**TOWN OF BROOKLYN
PLANNING AND ZONING COMMISSION
Regular Meeting Agenda
Wednesday, October 7, 2020
6:30 p.m.**

SUBJECT: Proposed Parking Expansion
Vachon Chevrolet
Assessor's Map 41, Lot Nos. 13A & 14
Providence Road (Route 6)
Brooklyn, Connecticut

ENGINEERING PLAN REVIEW PERTAINING TO PROPOSED PARKING EXPANSION VACHON CHEVROLET (ASSESSOR'S MAP 41, LOTS 13A & 14) PROVIDENCE ROAD (ROUTE 6) BROOKLYN, CT (March 20, 2020)

ENGINEERING PLAN REVIEW PERTAINING TO A 3-LOT SUBDIVISION (ASSESSOR'S MAP 34, LOT 52) PRINCE HILL ROAD BROOKLYN, CT (September 1, 2020)

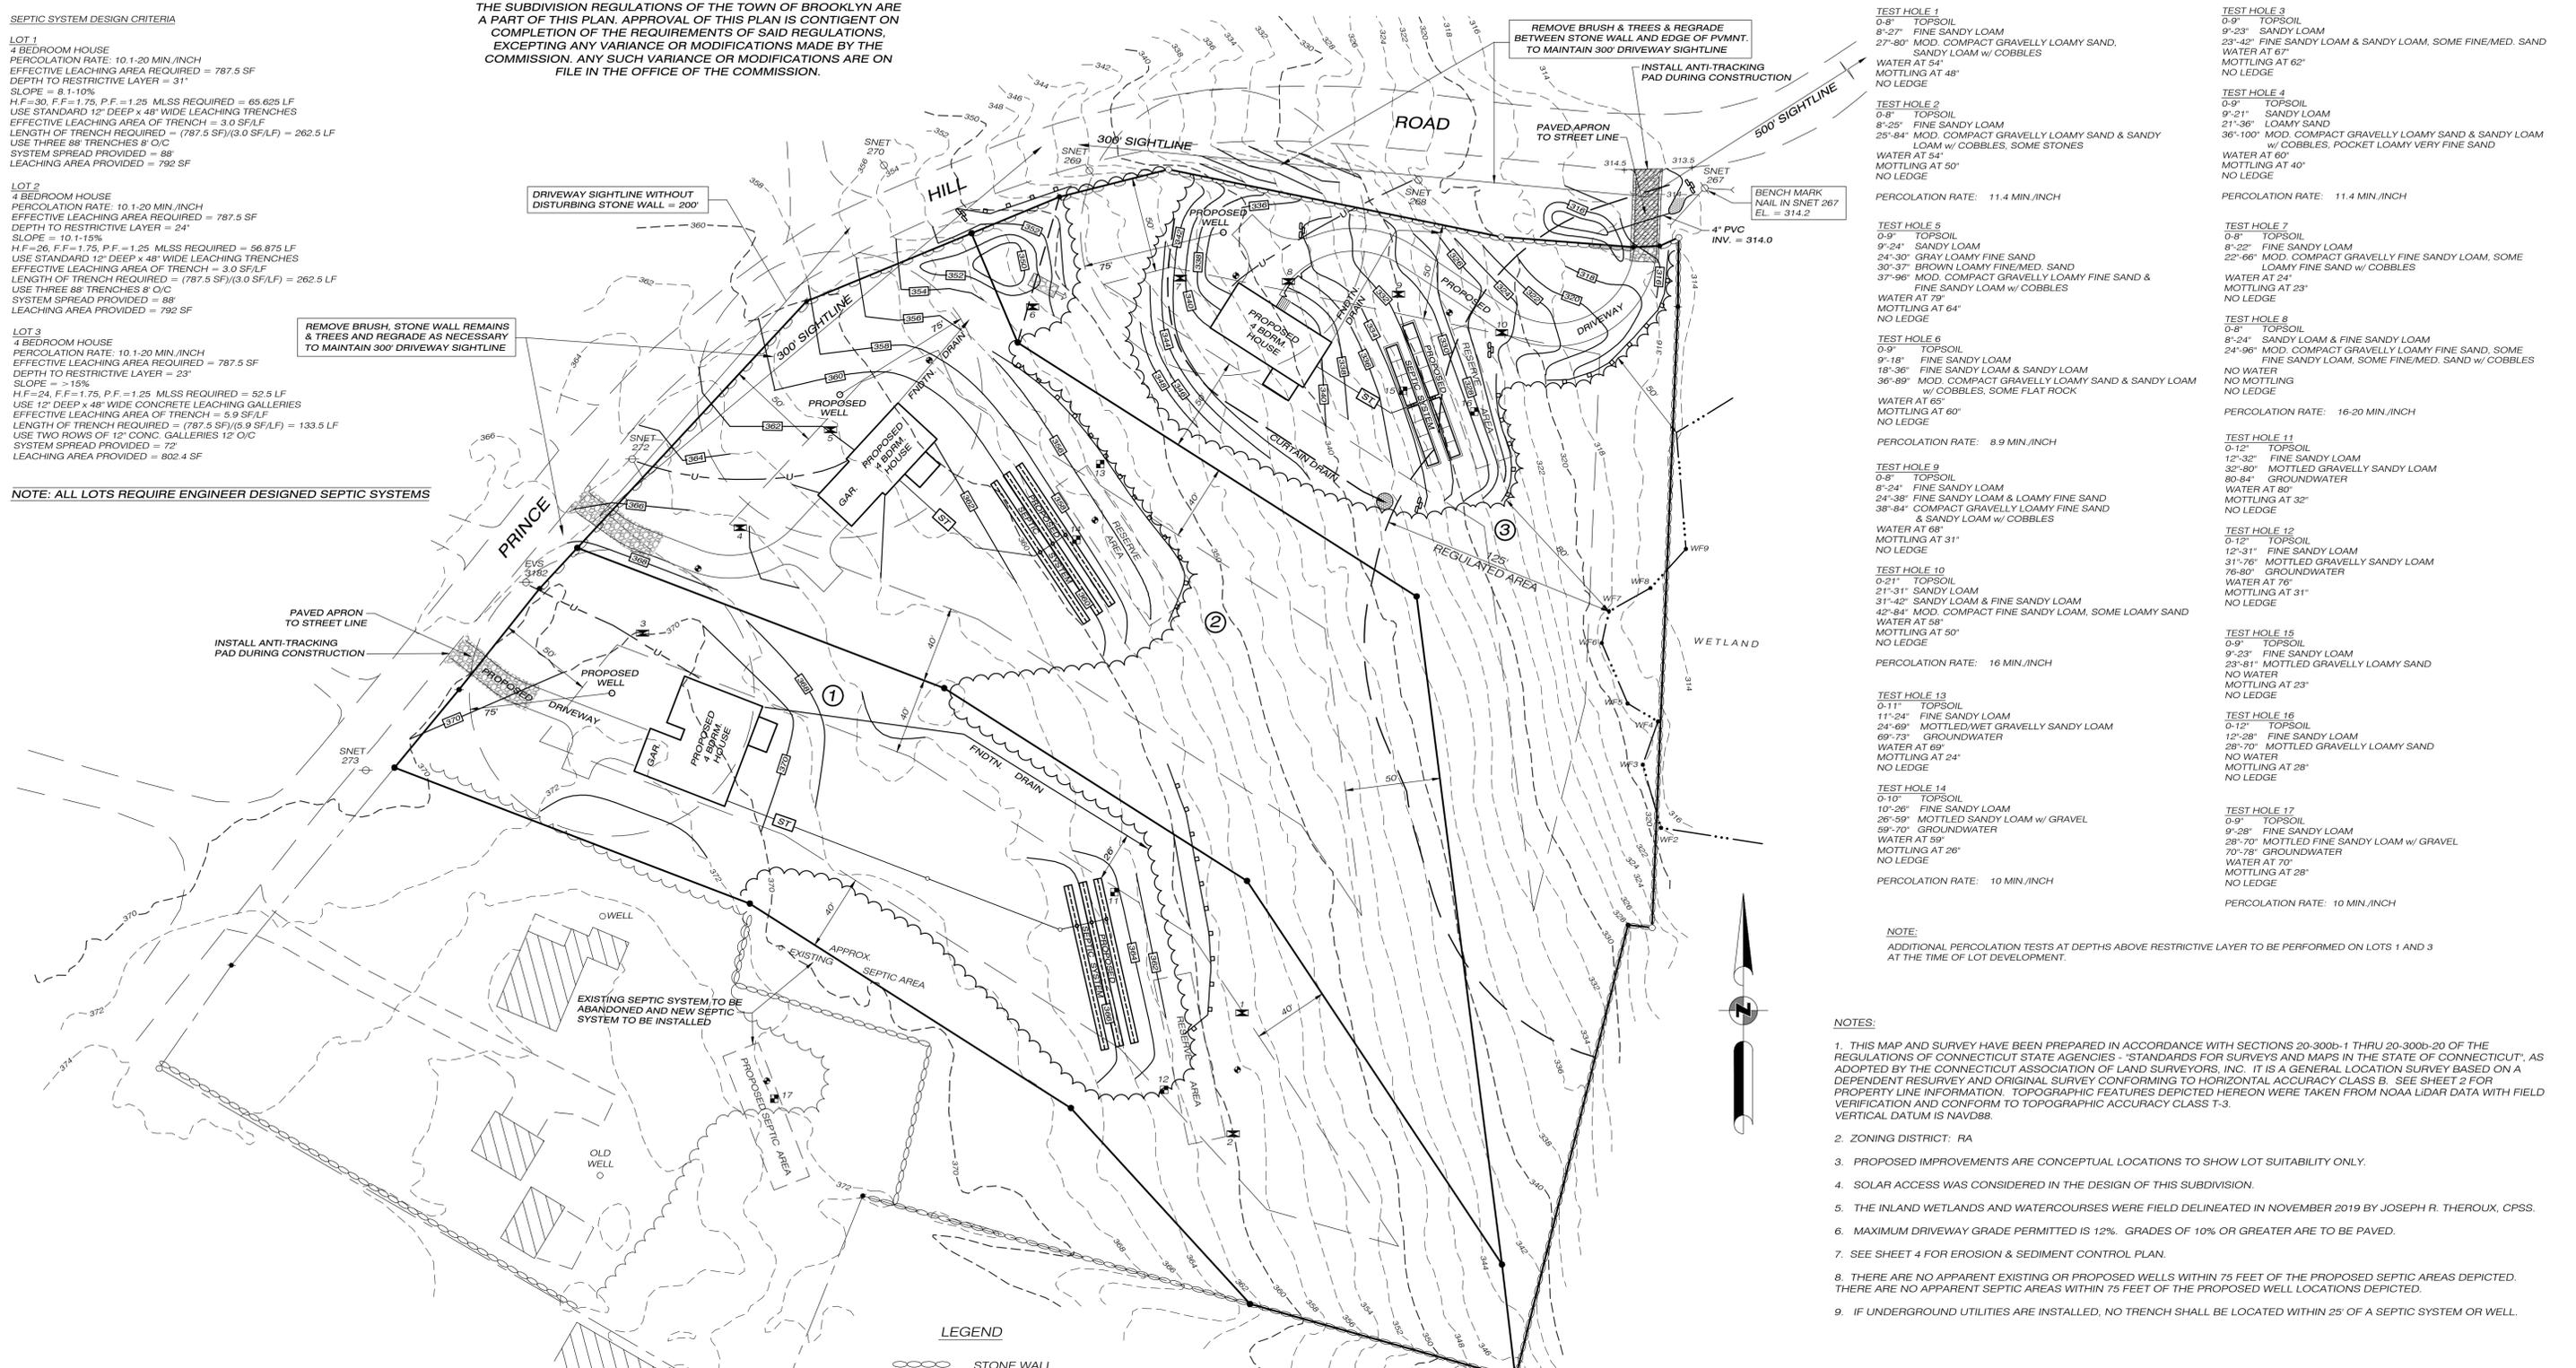
3. On Sheet 3 of 4 there is a note under the test hole data columns stating that "*Additional percolation tests at depths above restrictive layer to be performed on Lots 1 and 3 at the time of lot development.*" As far as I know, the need for this note remains unexplained. The consultant submitted a letter from the Northeast District Department of Health, dated July 20, 2020 and addressed to David and Nancy Bell, regarding the feasibility of future development of their land to be subdivided into three (3) lots with 4 bedroom houses. Said letter makes no mention of performing additional percolation tests and, therefore, I would like an explanation of what this means from the Applicant's consulting professional engineer (engineered septic systems are required).

4. There is no certified soil scientist signature block on Sheet 3 of 4 attesting to the validity of the flag line delineating the wetlands on the subject property.
